A d d e n d u m

Iowa Department of Transportation
Office of Contracts

B.O.	Proposal ID	Proposal Work Type	County	Project Number	Addendum
104	34-C034-094	PCC OVERLAY - UNBOUNDED	FLOYD	FM-C034(94)--55-34	19APR104.A01

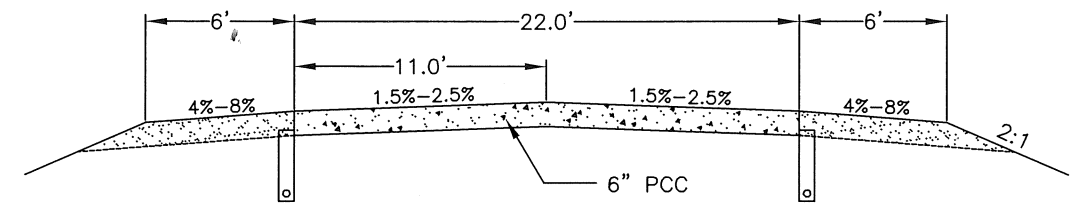
Replace SHEETS 2 of 4 and 4 of 4 with the attached SHEETS 2 of 4 and 4 of 4.

Typical Proposed Cross Section for 8" Paving
Not To Scale

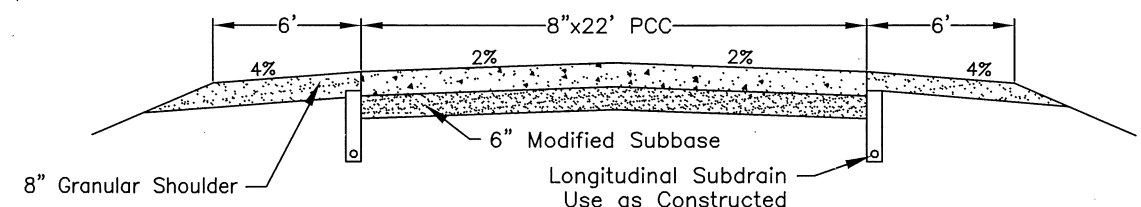
- Shoulders shall be 6' wide with 4% slope. See Shoulder Detail on sheet 4. Quantity includes Driveways and intersections.
- See tabulation for locations of 8" x 22' pavement. CD baskets are required at 12' spacing. No skew on transverse joints. Longitudinal joint shall be either BT-1 or L-1. Class 3 durability aggregate is required. The contractor shall provide certified plant inspection for this project. IDOT Standard Specification 2316 (pavement smoothness) shall not apply. Macrotexture shall be provided by longitudinal grooving. Maturity Method of testing shall be used for determining the time for opening pavement to traffic and shall be incidental. See intersection detail on sheet 3. Construction staking (string or stringless) supplied by Floyd County. Saw cutting for transition pavement and at tie in locations shall be included in the price of the PCC Paving.
